Office Action Summary

10/672,536

HURN, MARTYN

DETAILED ACTION

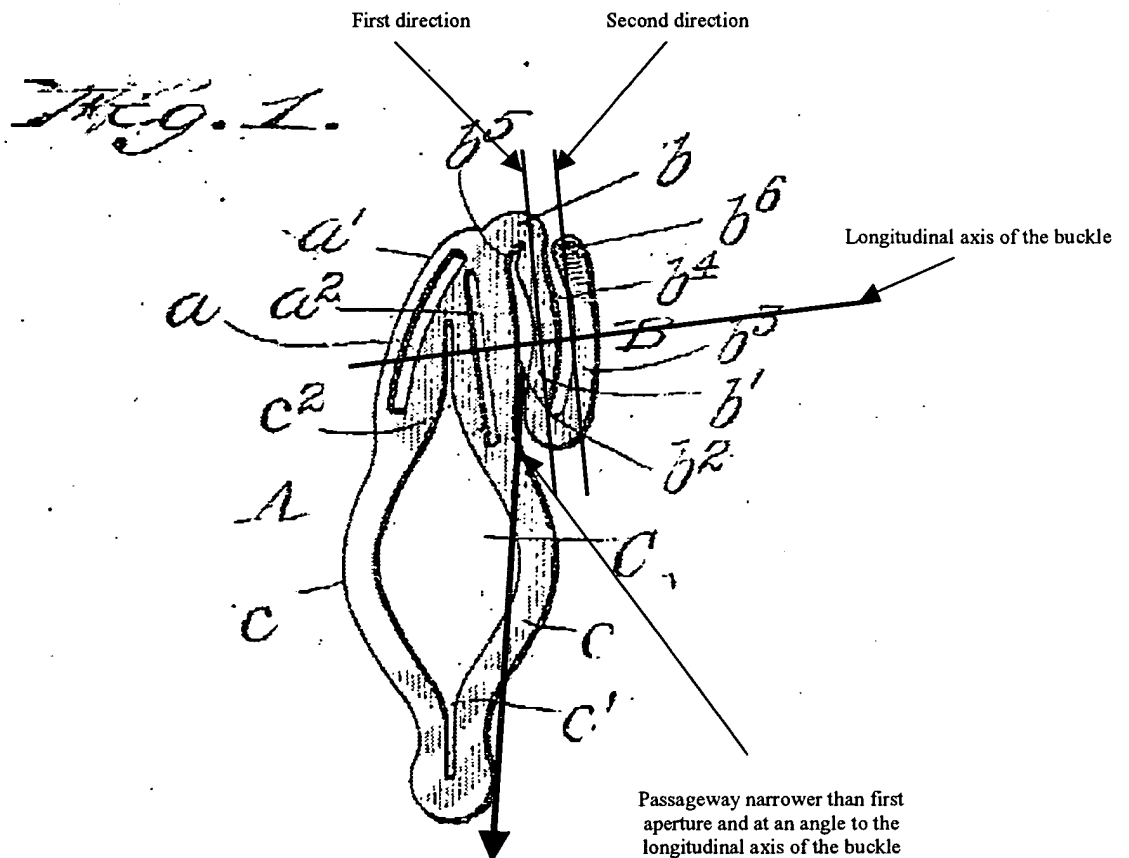
Claims 3 and 4 are rejected under 35 U.S.C. §102(b) as being clearly anticipated by Nonnemacher (US 837103).

Nonnemacher (figure 1 reproduced below with added identifiers) teaches a buckle comprising: a main body, the main body including a first connection means including at least one bar integrally formed with the main body of the buckle, and defining at least one elongate slot, a, therein adapted for receiving a length of webbing or the like; and a securing portion, the securing portion including a second connection means including a first arm, b', integrally formed with the main body of the buckle, wherein the first arm has proximal and distal ends, the proximal end being attached to the main body of the buckle and the first arm extending from the main body of the buckle in a first direction and defining a first aperture, b2, therewith, and the first aperture having an opening at one end, facing in the first direction, through which a captive loop of

webbing may be guided into the first aperture if so desired; wherein a second arm, b3, is integrally formed with the main body of the buckle, wherein the second arm, b3, extends from the first arm, b', in a second direction, substantially opposite to the first direction, and defines a second aperture, b4, therewith, wherein the second aperture has an opening at one end, facing in the second direction, adapted to be inherently capable of receiving the captive loop of webbing. The second arm, b3, is turned through approximately 180° relative to the first arm and faces in a direction opposite to that of the first arm, and is in spaced apart parallel relationship to the first arm to define the second aperture. The term parallel has the recognized definition "Designating curves or surfaces everywhere equidistant"¹. The claim does not require the arms to be straight and the first curved arm, b', and the second curved arm, b3, define a slot, b4, of uniform width for the webbing, thereby defining the arms as being parallel under this new interpretation. The second arm, b3, is bent outward slightly at its free end, b6, to permit easier assembly of the webbing in the slot b4, but the assembly point does not preclude the arms being considered parallel over the operative receiving area of the webbing. The captive loop of webbing is not claimed in combination and the buckle of Nonnemacher is fully capable of receiving a captive loop if so desired. The two "means" statements, "first connection means" (claim 3, line 2) and "second connection means" (claim 3, line 7) are not accorded interpretation under 35 U.S.C. 112, sixth paragraph because each is followed by language specifically describing the structure performing the function. The elongated slots, a, a2, are considered to be defined within two bars with the remaining portion defines a grip portion, c. The web passageway leading to the first

aperture, b2, is considered inclined relative to an axis of the buckle and is narrower than the first aperture.

While the device of Nonnemacher is not disclosed as used upon a rucksack, the device can inherently be used upon a rucksack if so desired and the rucksack is not claimed in combination.

In regard to claim 4, the second arm, b3, has a free distal end, b6, which defines with the first arm, b', a second open web passageway leading into the second aperture.
